CONTRACT CHANGE ORDER NO. ____
SHEET ____ OF ____

MARK	DATE	DESCRIPTIONS	BY	CH'D	CCO#
3	08/10/12	TOWER CAULKING	NV	MN	256
2	07/07/08	CAULKING	MN	NV	66
1	06/23/06	SPLICE PLATES PER ISM	MN	NV	21

SAN FRANCISCO OAKLAND BAY BRIDGE
EAST SPAN SEISMIC SAFETY PROJECT
SELF-ANCHORED SUSPENSION BRIDGE
(SUPERSTRUCTURE & TOWER)

TOWER SPLICE DETAILS NO. 3

TYPICAL TOWER SHAFT SPLICE #1

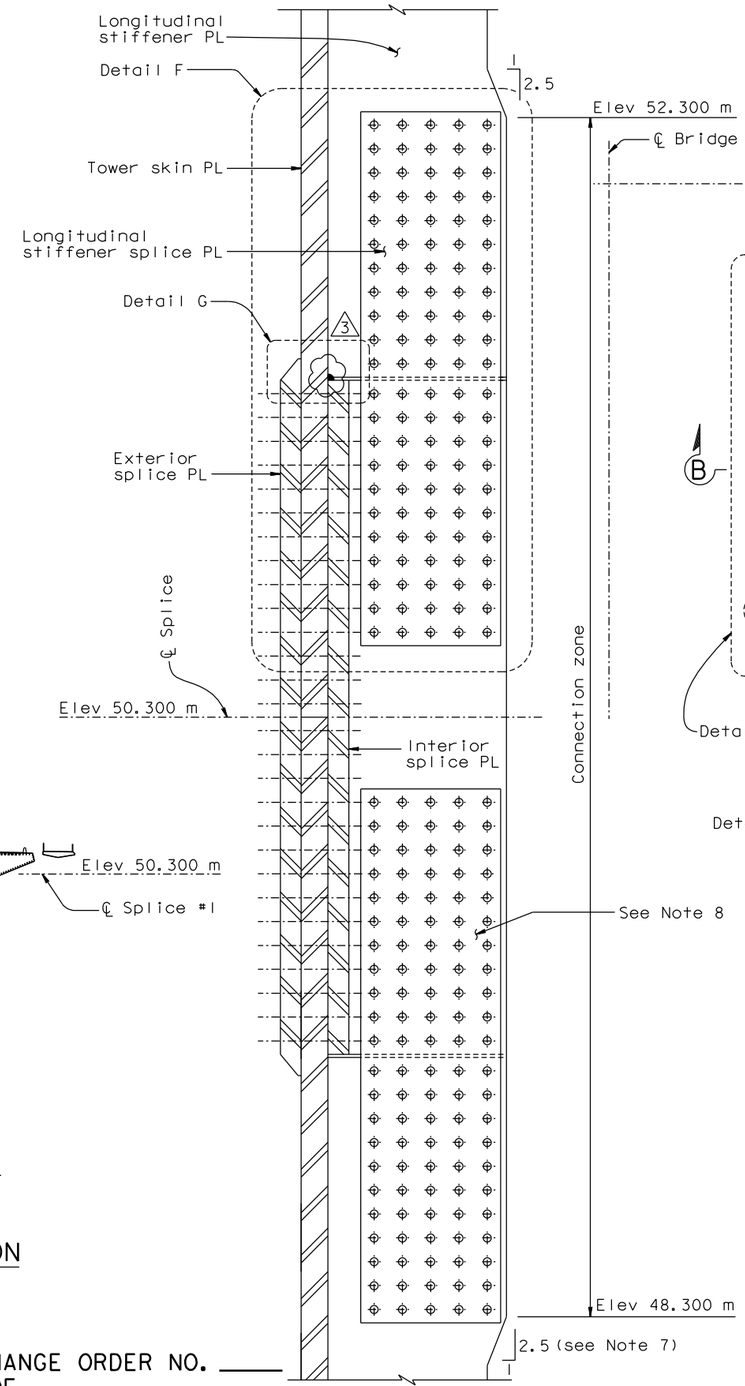
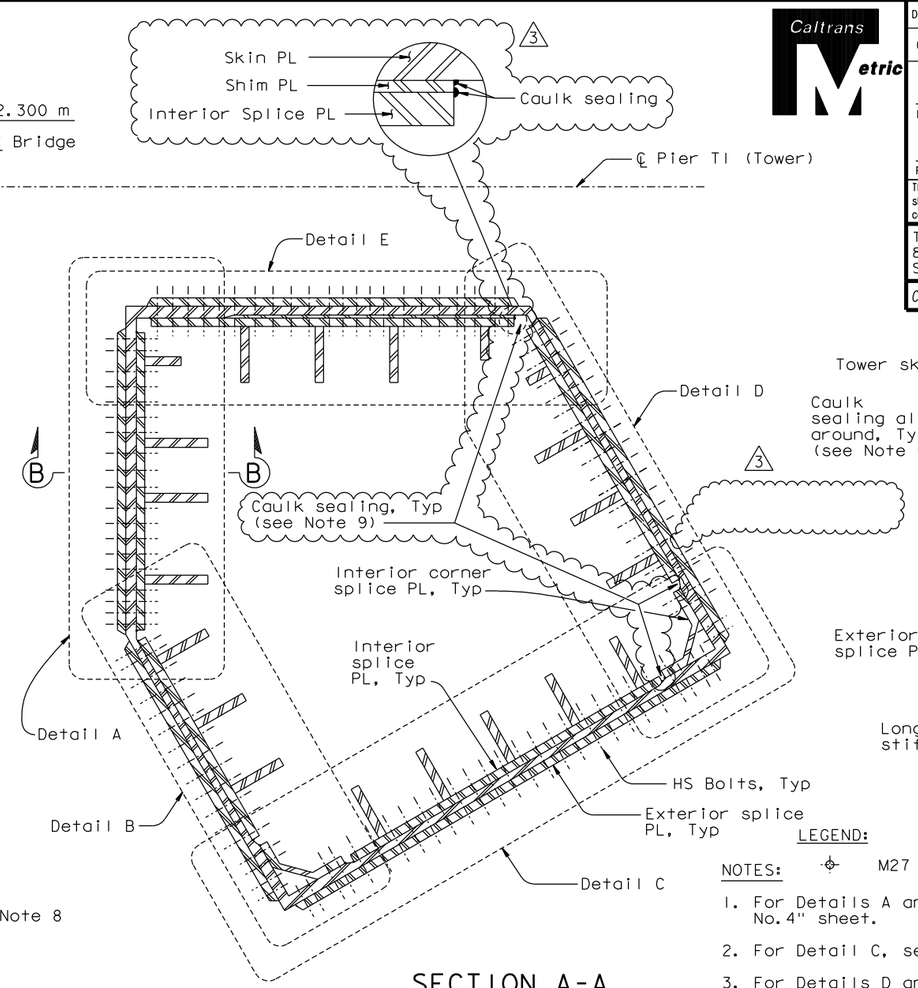
8. For stiffeners A1, B4, E4, E7, and D4, see "Tower Splice Details No.7" sheet.
9. (3) Caulk sealing shall be applied along the exposed upper horizontal edge and exposed vertical edges of all interior splice plates, interior corner splice plates, and shim plates. For upper horizontal edges, caulk sealing shall be continuous through the longitudinal stiffener plates by filling the gap between longitudinal stiffener plates and interior splice plates.

TYPICAL TOWER SHAFT SPLICE #2

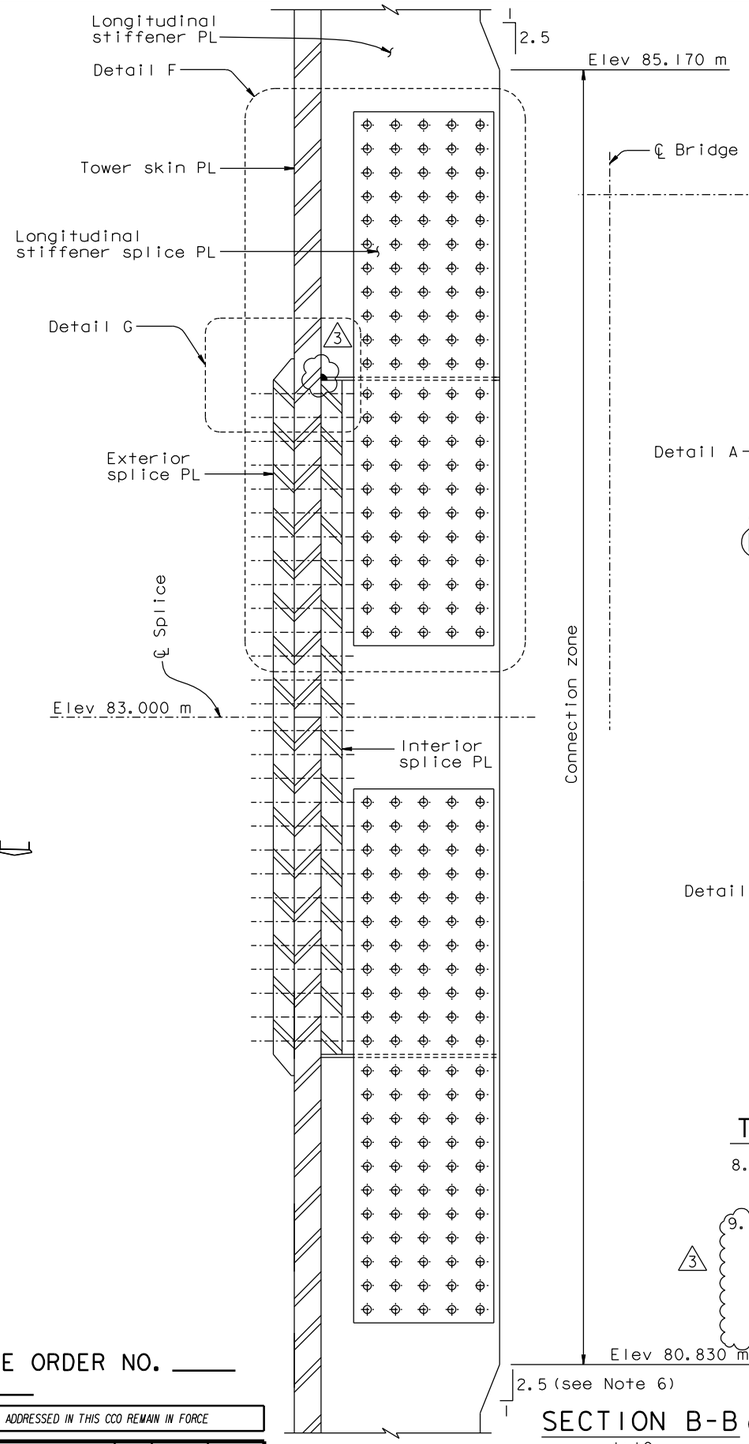
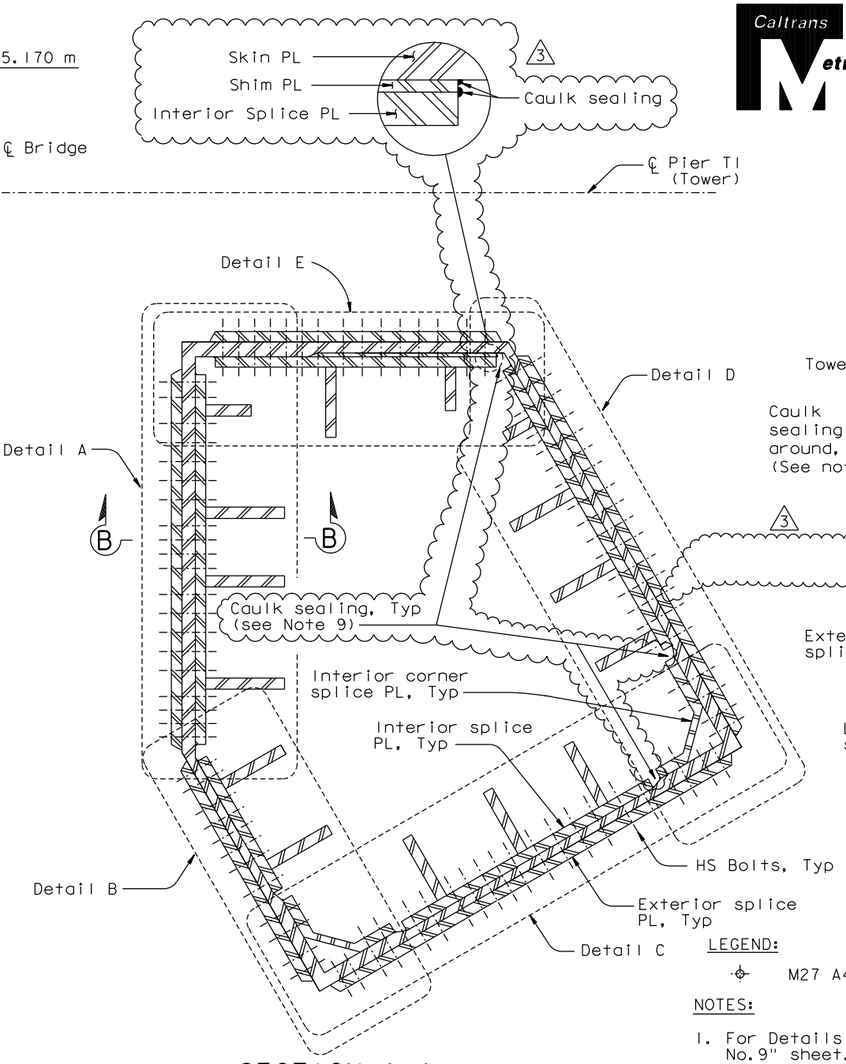
9. Caulk sealing shall be applied along the exposed upper horizontal edge and exposed vertical edges of all interior splice plates, interior corner splice plates, and shim plates. For upper horizontal edges, caulk sealing shall be continuous through the longitudinal stiffener plates by filling the gap between longitudinal stiffener plates and interior splice plates.

MARK	DATE	DESCRIPTIONS	BY	CH'D	CCO#
3	08/10/12	TOWER CAULKING	NV	MN	256
2	07/07/08	CAULKING	MN	NV	66
1	06/23/06	SPLICE PLATES PER ISM	MN	NV	21

TYPICAL TOWER SHAFT SPLICE #3

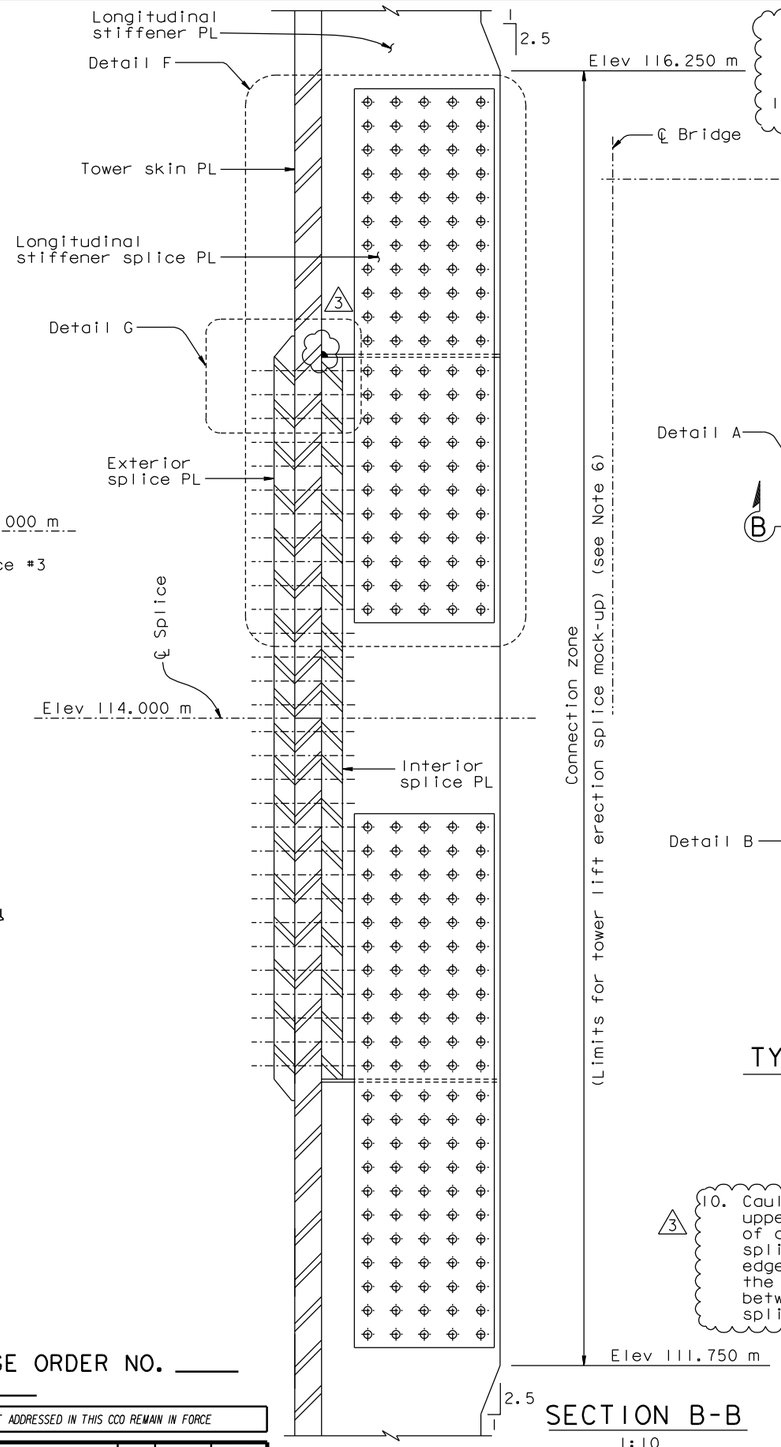
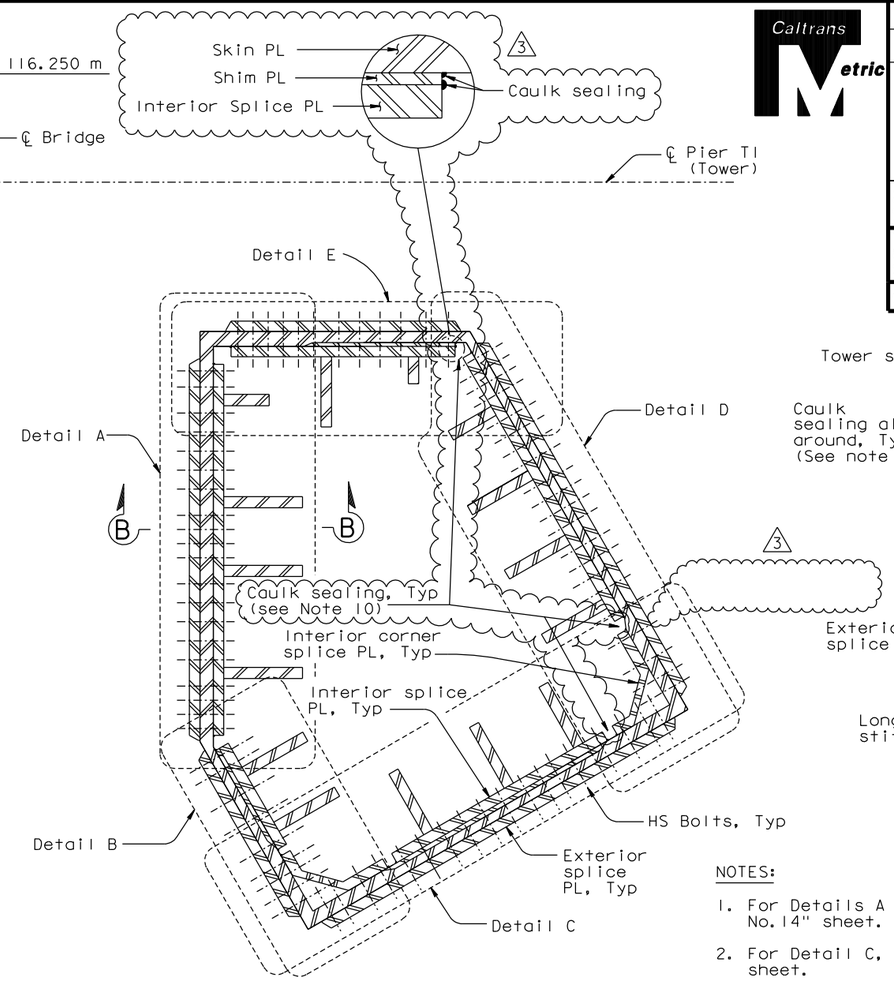
3 10. Caulk sealing shall be applied along the exposed upper horizontal edge and exposed vertical edges of all interior splice plates, interior corner splice plates, and shim plates. For upper horizontal edges, caulk sealing shall be continuous through the longitudinal stiffener plates by filling the gap between longitudinal stiffener plates and interior splice plates.

MARK	DATE	DESCRIPTIONS	BY	CH'D	CCO#
3	08/10/12	TOWER CAULKING	NV	MN	256
2	07/07/08	CAULKING	MN	NV	66
1	06/23/06	SPLICE PLATES PER ISM	MN	NV	21

TOWER SHAFT SPLICE #4
(Tower Grillage to Tower Shaft Splice)

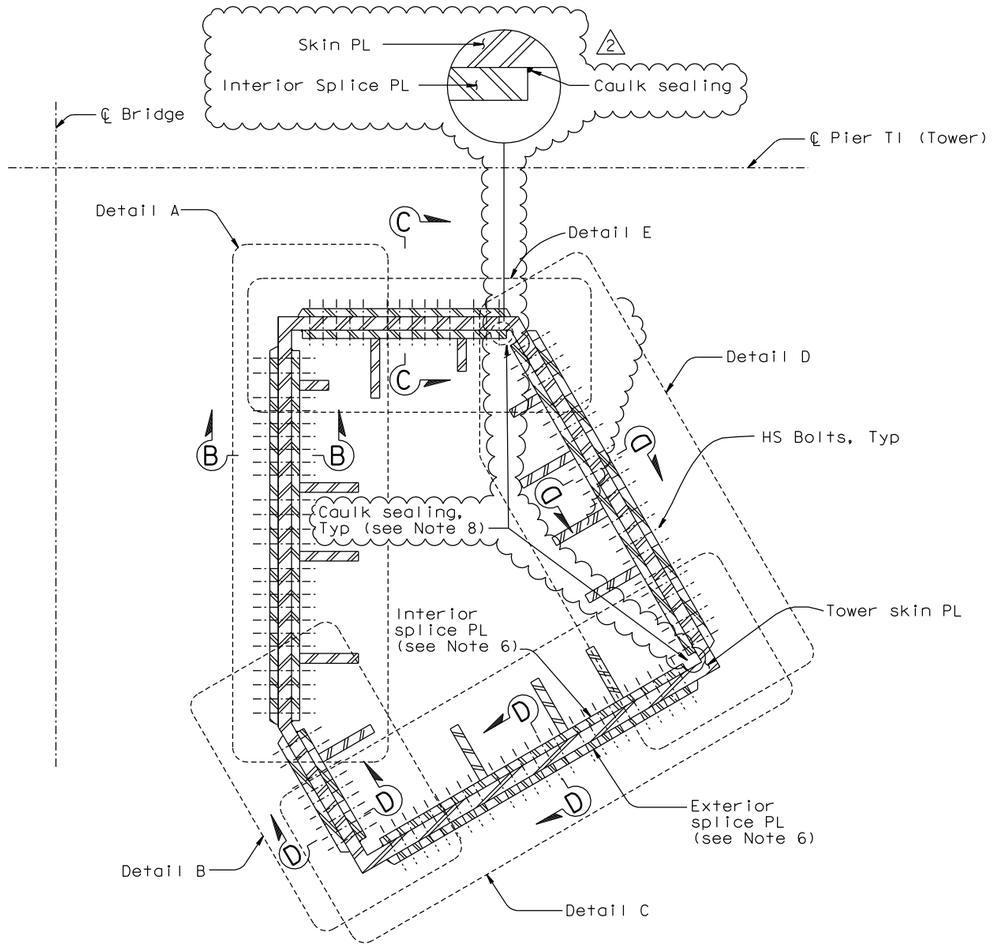
8. Caulk sealing shall be applied along the exposed upper horizontal edge and exposed vertical edges of all interior splice plates, interior corner splice plates, and shim plates. For upper horizontal edges, caulk sealing shall be continuous through the longitudinal stiffener plates by filling the gap between longitudinal stiffener plates and interior splice plates. (2)

MARK	DATE	DESCRIPTIONS	BY	CH'D	CCO#
2	08/10/12	TOWER CAULKING	NV	MN	256
1	06/23/06	SPLICE PLATES PER ISM	MN	NV	21

TOWER SPLICE DETAILS NO. 19

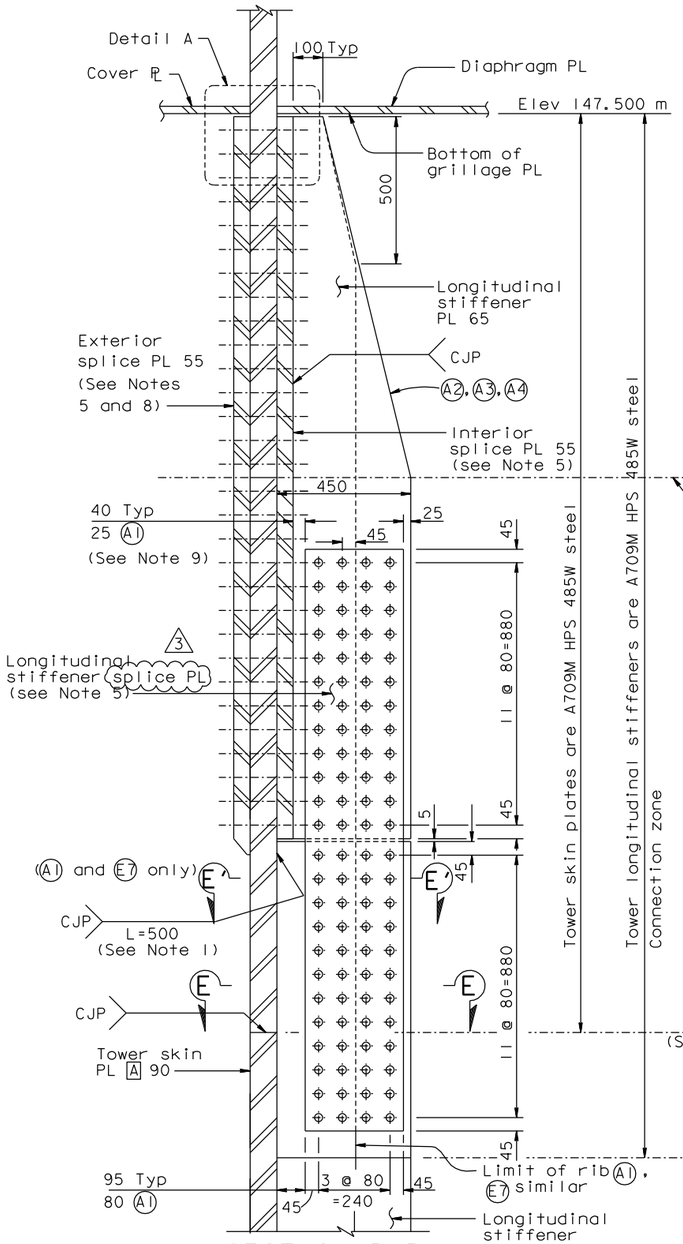
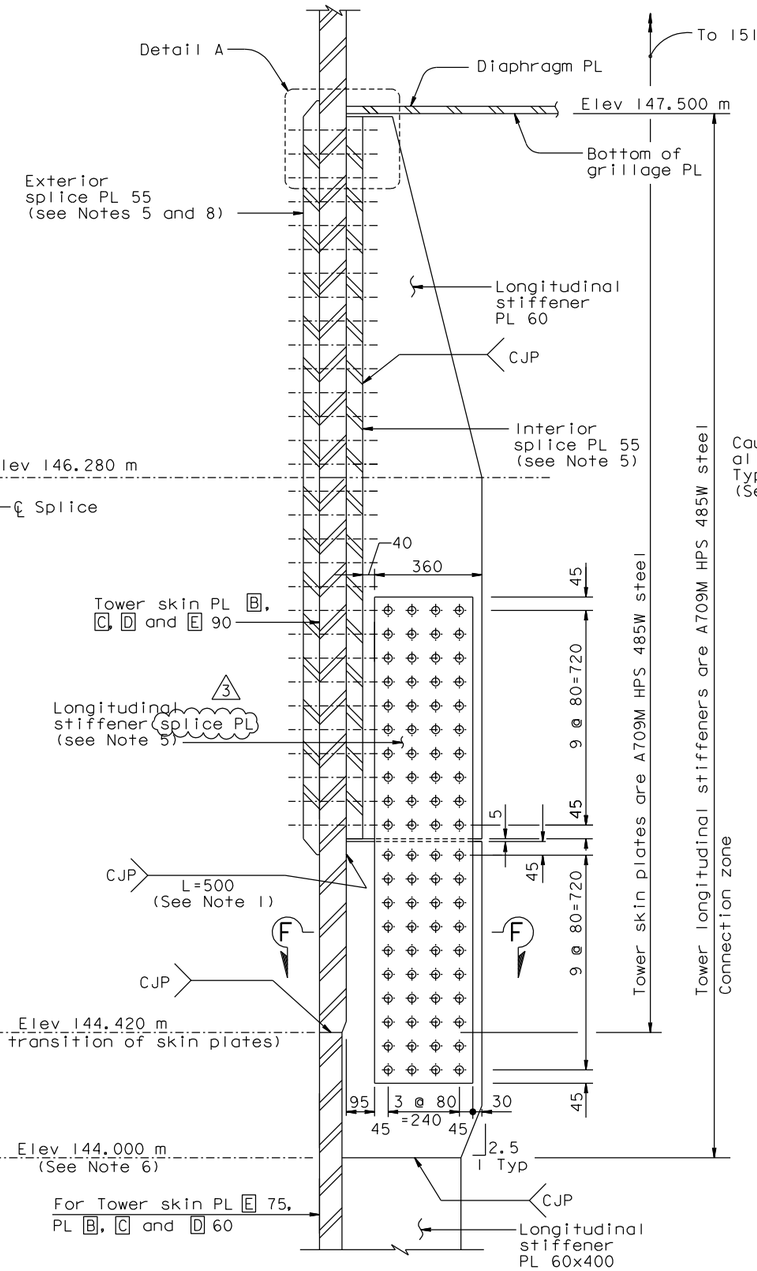
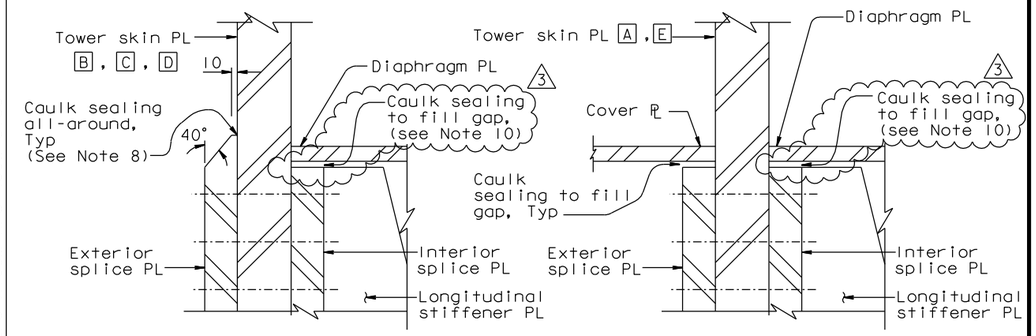
10. Caulk sealing shall be applied along the exposed upper horizontal edge and exposed vertical edges of all interior splice plates. For upper horizontal edges, caulk sealing shall fill the gap between the diaphragm plates and interior splice plates.

MARK	DATE	DESCRIPTIONS	BY	CH'D	CCO#
3	08/10/12	TOWER CAULKING	NV	MN	256
2	07/07/08	CAULKING	MN	NV	66
1	06/23/06	LONG. STIFFENER GAP & MISC.	MN	NV	21
